PRODUCT INFORMATION BULLETIN

DATE: March 2000

SUBJECT: Gaseous fuel hose on 4.3 Liter

MODELS AFFECTED: All 35 through 45 kW Natural Gas and LP Vapor Gas 2000 Series Generators shipped prior to February 11, 2000.
NOTE: This does not apply to the gear driven or Guardian style 4.3 Liter Units.

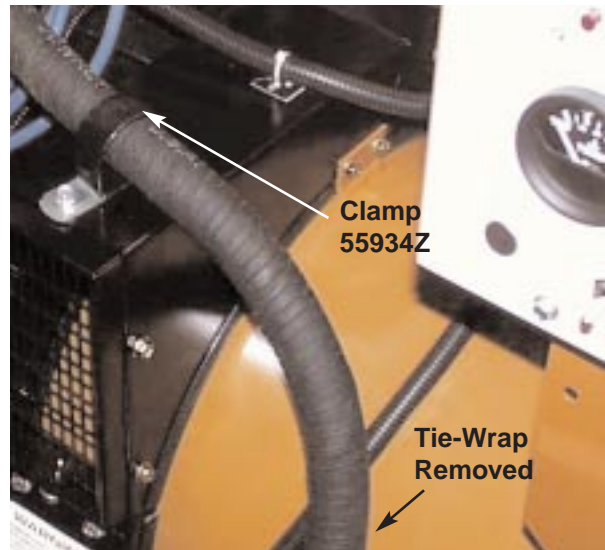
PROBLEM: Fuel line too close to exhaust crossover pipe.

CORRECTIVE ACTION: Re-position fuel line by installing a clamp on the blower shroud.

PROCEDURE: Order the 55934Z clamp from your normal source of Generac parts. Remove and discard the tie-wrap that retains the fuel line to the stator can. Add clamp on the blower shroud, facing it to the right of the generator. Use the existing hardware on the top of the shroud to hold down the clamp. This will move the fuel line away from the exhaust crossover tube. The minimum clearance **MUST** be two inches below the exhaust crossover tube.

SUBJECT: GR Series Radiator Side Baffles

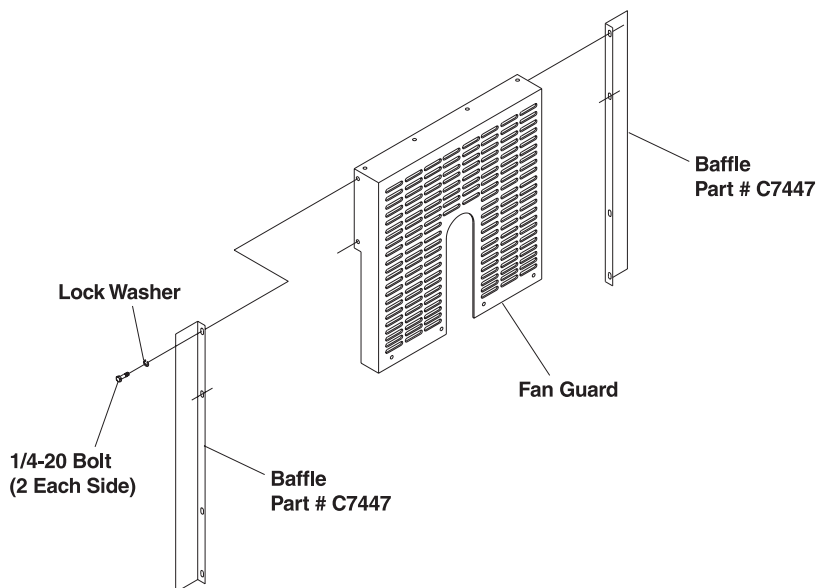
PROBLEM: Side baffles may be missing on some units. Without baffles, unit may overheat under full load condition.

CORRECTIVE ACTION: Order and install side baffles.

PROCEDURE: Order 2 baffles, Part Number C7447, from your normal source of Generac Parts. Install the baffles on the right and left sides of the fan guard using the existing 1/4-20 screws already in place on the fan guard. (Two on each side.)
